Modifying Base for Disaster Syst

Tenn. State Univ.	
CASS 2-m AST Project	
07/22/02	AST-11-R06
J.A.E.

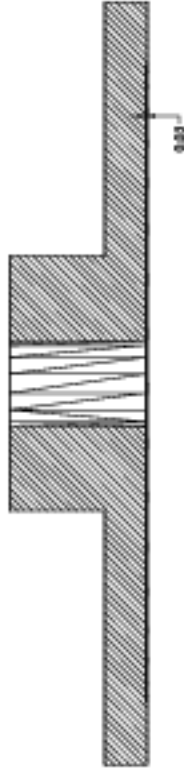
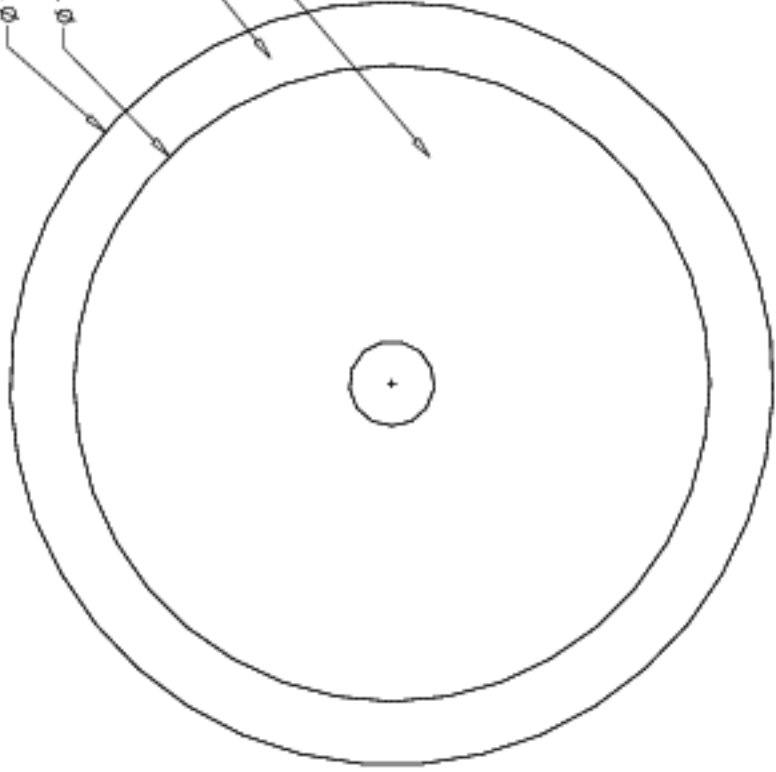
Mill flat
Recess
0.03 in

Modification of part 11-261,
Base Plate for the disaster
system. The plate is to be
trued up on a lathe and
relieved by 0.03 inches in its
inner parts, as shown.
